ADDENDUM NO. 2

SUBJECT: Solicitation No. AA018B

TITLE: Miami International Airport (MIA) South Terminal Concourse H Rehabilitation – Phase 1

G0.02
SHEET NO.: 2 OF 42

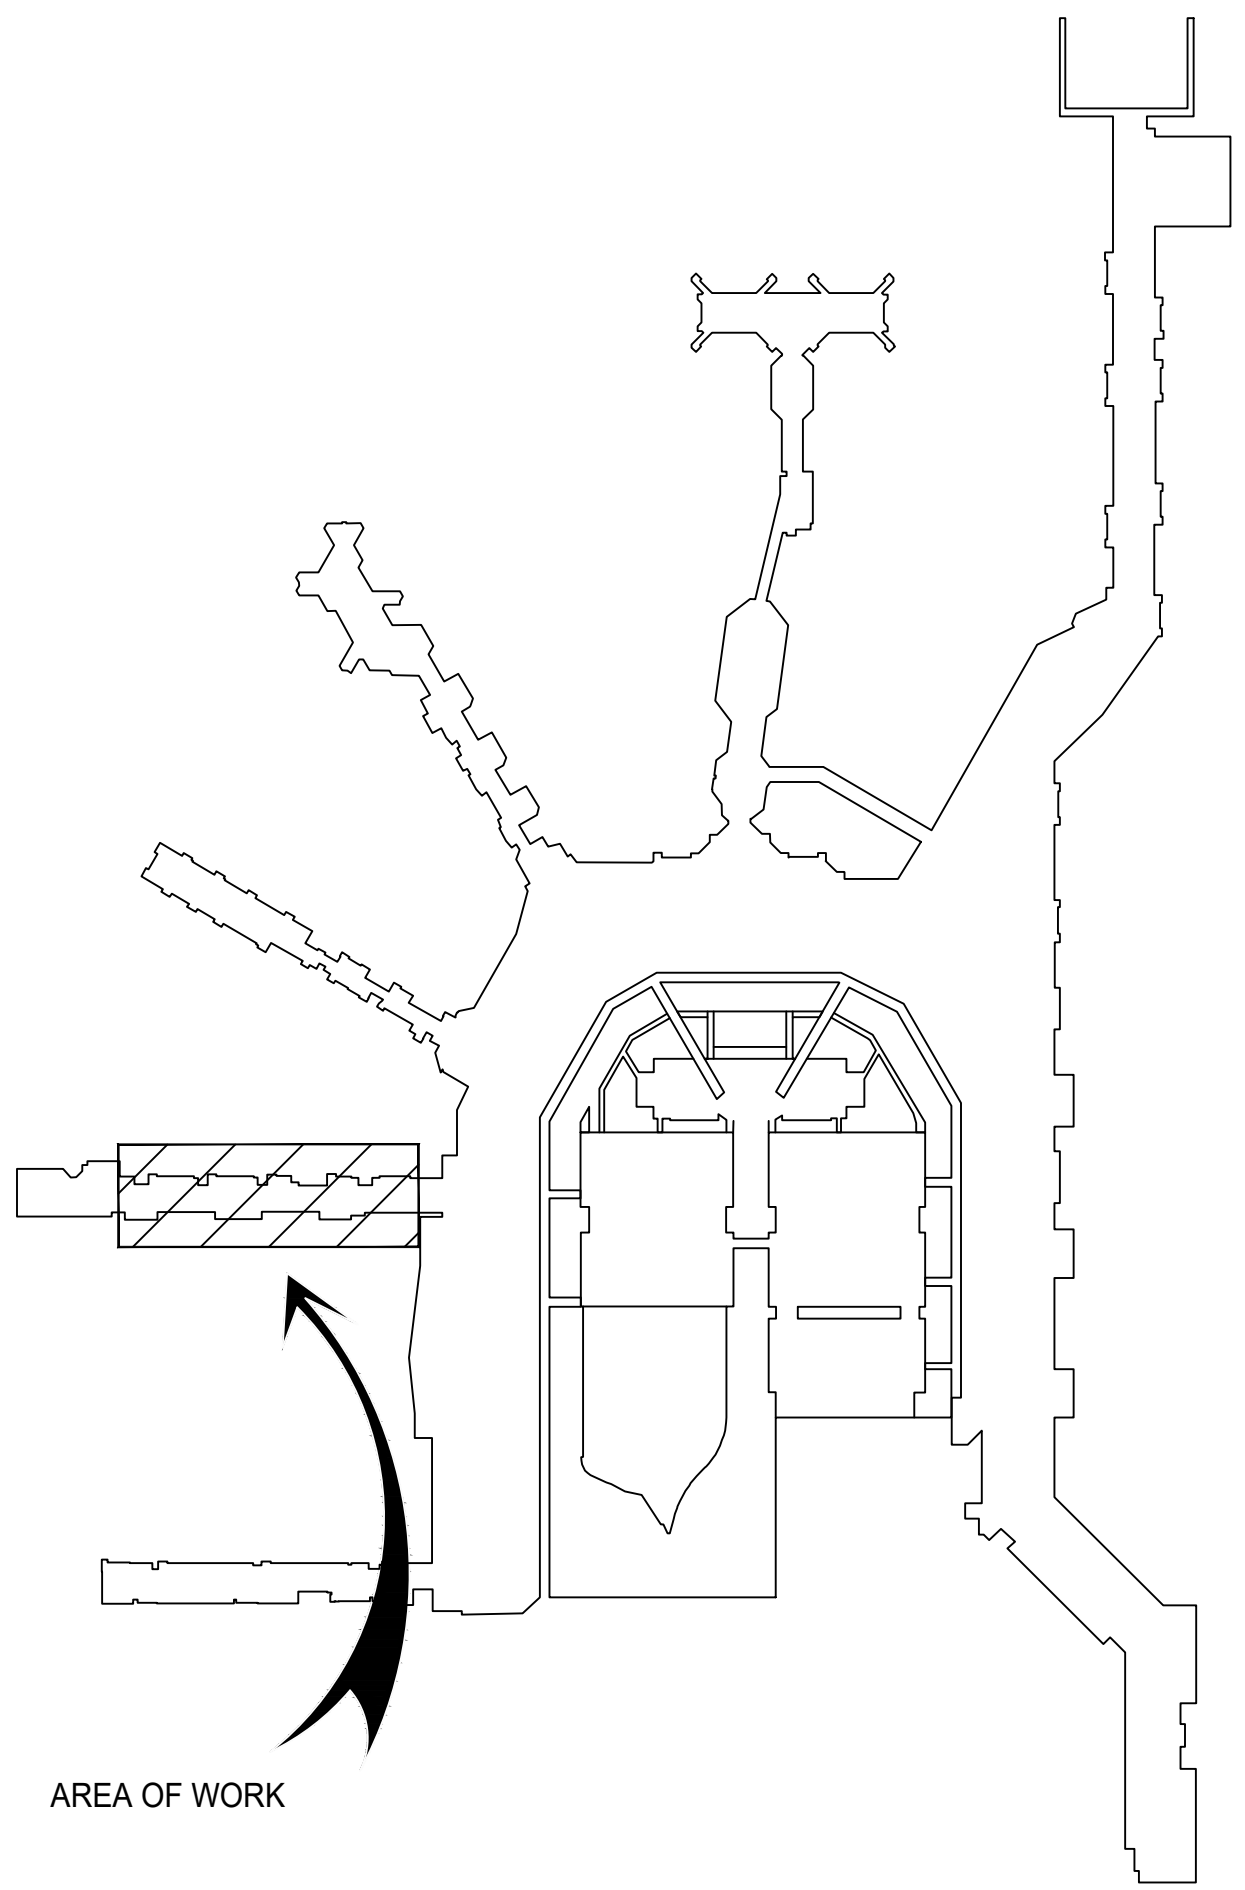
a. Drawing G0.02 Scope #2 - Remove the following in its entirety:

REMOVE AND REPLACE THE FAILED WINDOW WALL DOWN TO THE EXISTING STRUCTURE AND REPLACE WITH FAOUR GLASS TECHNOLOGIES SERIES 'SLIMPACT XL' IMPACT RATED WINDOW WALL SYSTEM (L.M.I.) OR APPROVED EQUAL. GATE H3.

b. Drawing G0.02 Scope #2 - Replace with the following:

REMOVE AND REPLACE THE FAILED WINDOW WALL DOWN TO THE EXISTING STRUCTURE AND REPLACE WITH ALDORA ALUMINUM & GLASS PRODUCTS SERIES SMI-175 ALUMINUM WINDOW WALL SYSTEM OR APPROVED EQUAL. GATE H3.

- REMOVE AND REPLACE THE FAILED WINDOW WALL DOWN TO THE EXISTING STRUCTURE AND REPLACE WITH ALDORA ALUMINUM & GLASS PRODUCTS SERIES SMI-175 ALUMINUM WINDOW WALL SYSTEM OR APPROVED EQUAL GATE H3.

DATE: FEBRUARY 4, 2022
 SCALE: AS SHOWN
 DESIGN BY: E.M.Z.
 DRAWN BY: C.N.Z.
 REVIEWED BY: E.M.Z.
 PROJECT NO.: 18-0305.02
 DRAWING TITLE: FRAMING PLAN
 DRAWING NO.: S1.01
 SHEET NO.: 27 OF 42

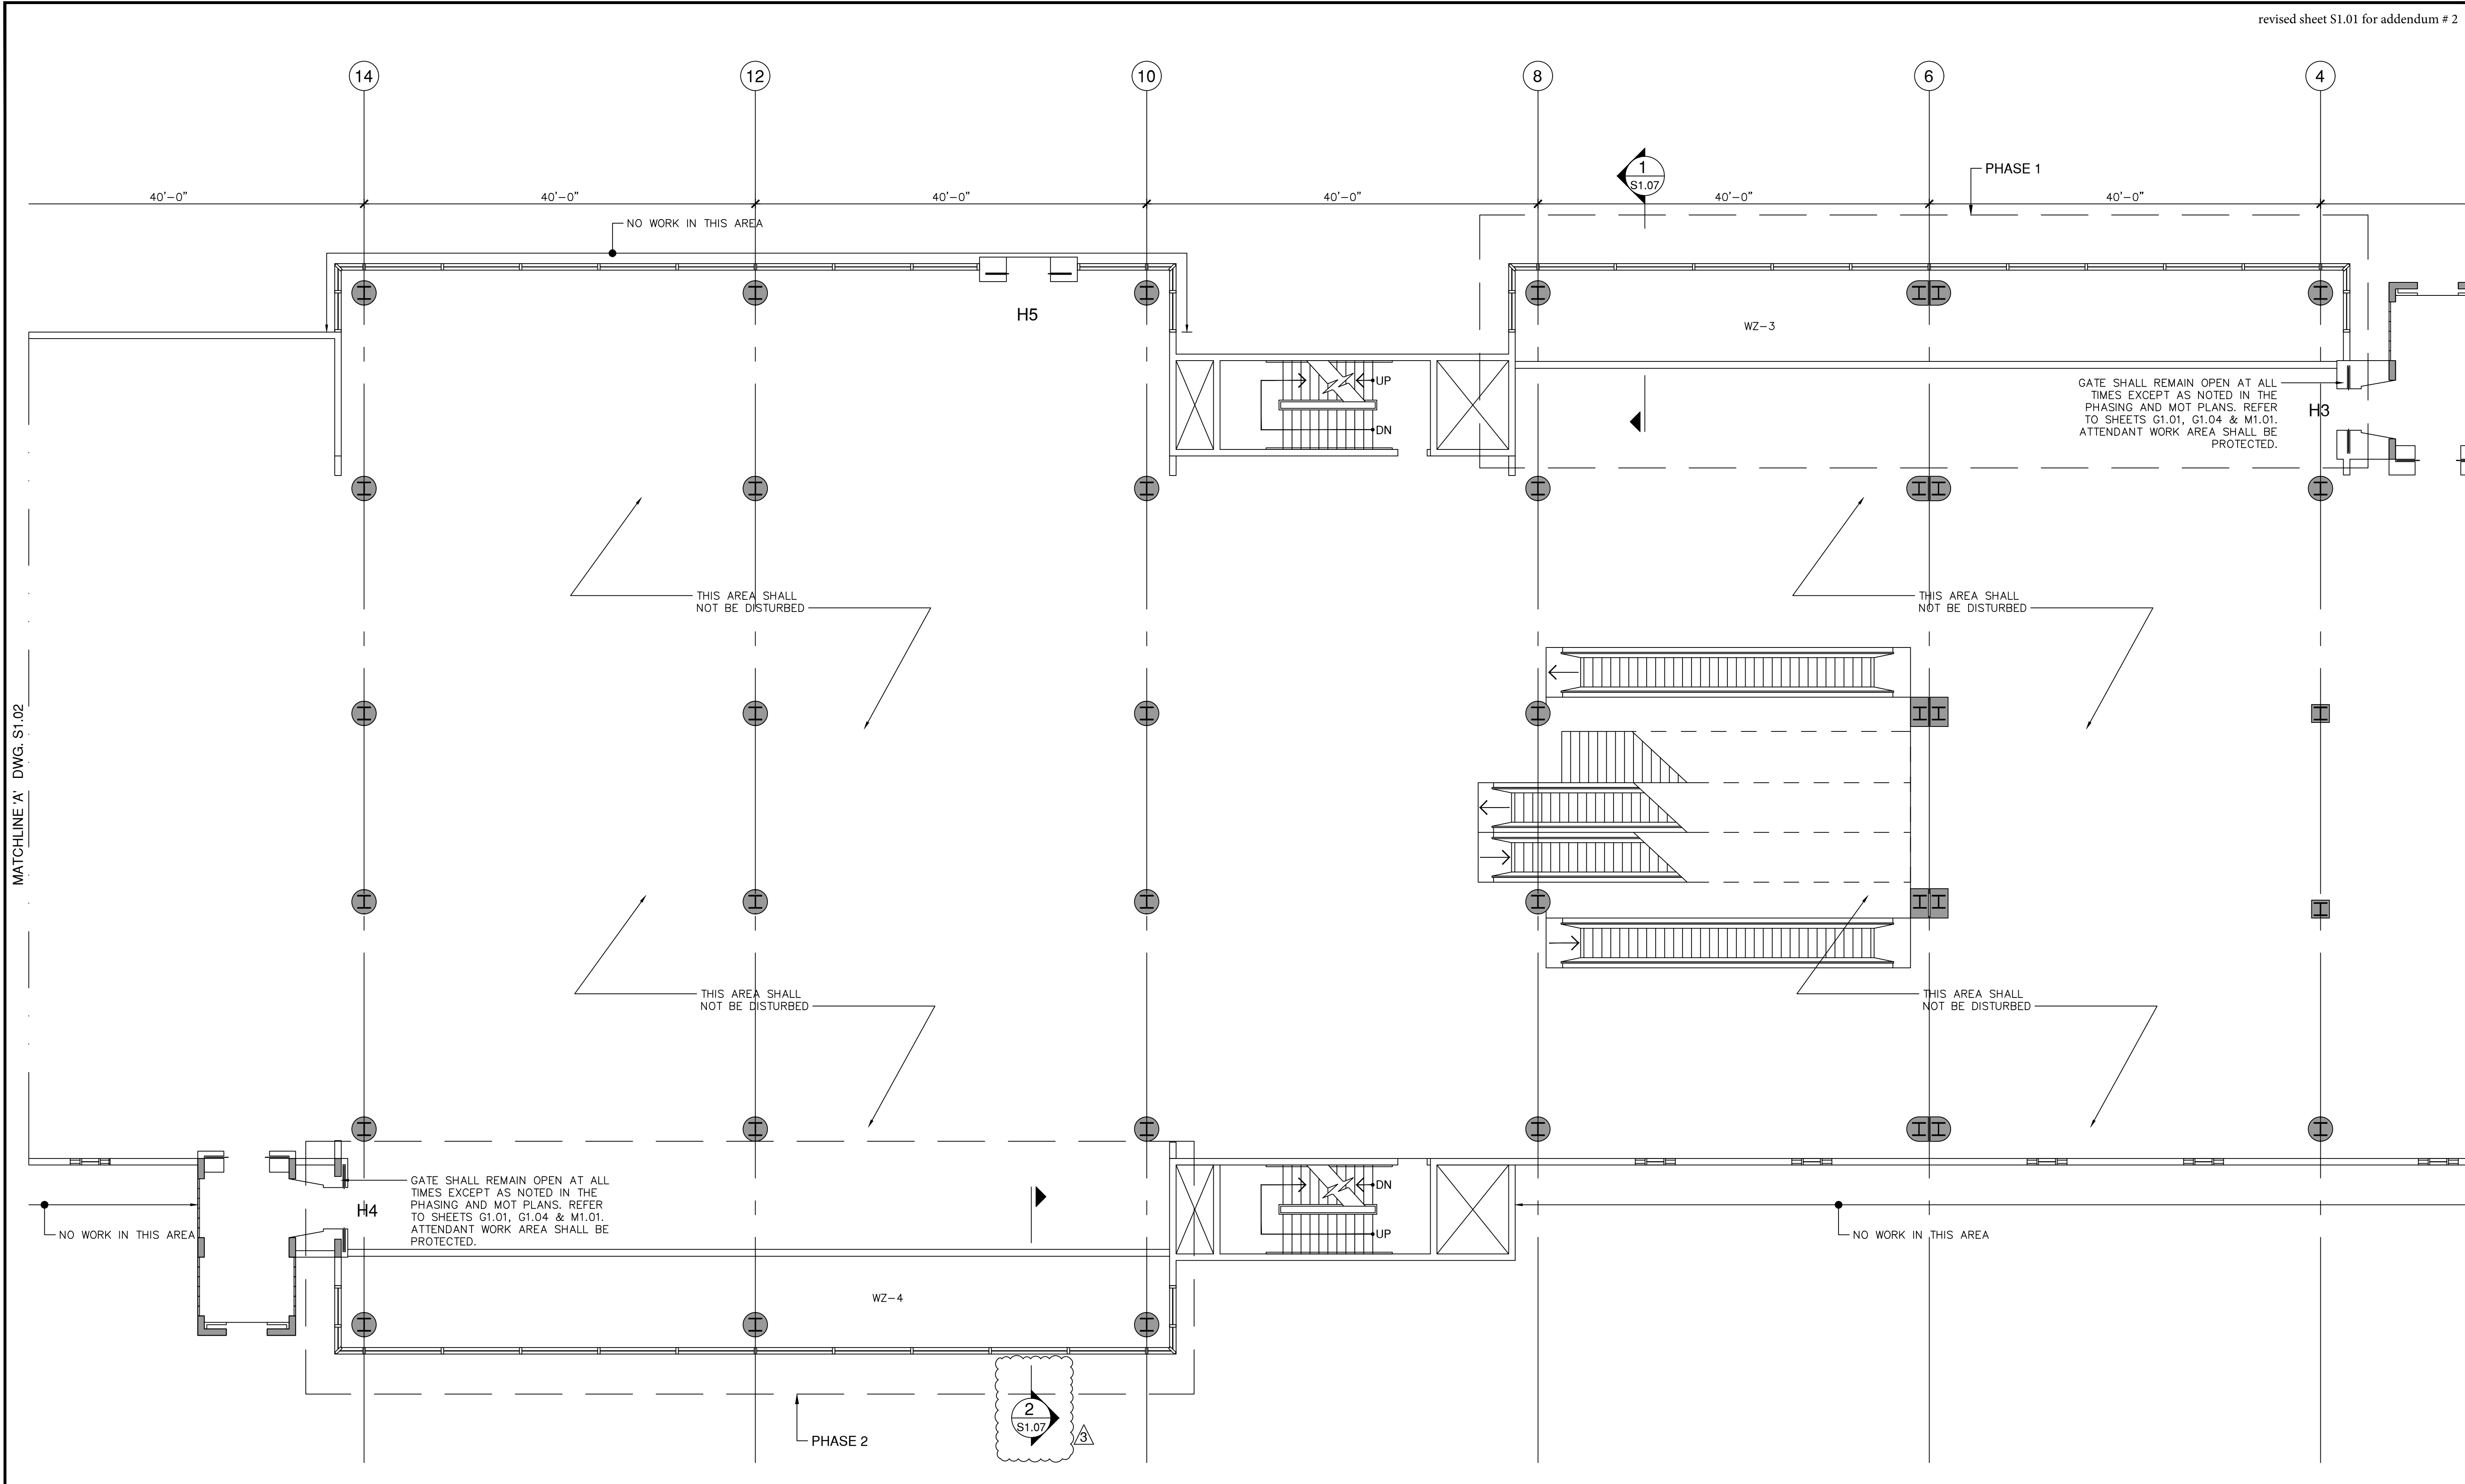
c. DRAWINGS S1.01 THROUGH S1.07 - Added section mark 2/S1.07 in work zones WZ-4, WZ-6/8, WZ-10 (DRAWING S1.07) Added section 2/s1-07, added details E/S1.07, F/S1.07, G/S1.07, H/S1.07
